Probashi Knitwear Ltd. (Relocated)

12 November 2023

Observation-1: Mismatch in as-built drawing. (Main Production Building)

Column Layout (1st floor)

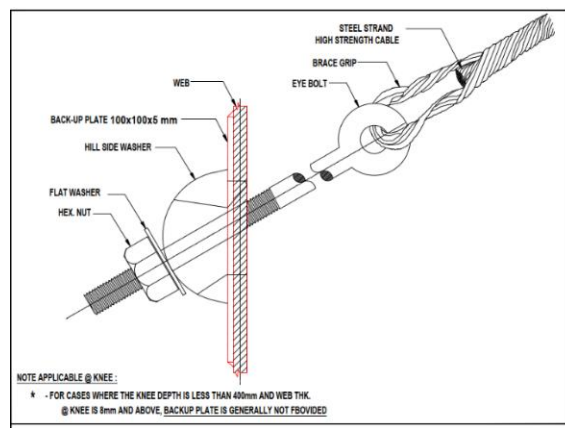
Description: Web of SC 207 column on 1st floor not matched with drawings. 300 mm web was found instead of 350 mm. Moreover, the wall bracing sectional details of grid 07 did not fully match with onsite condition. The building engineer is required to survey the structure and prepare accurate as-built drawings.
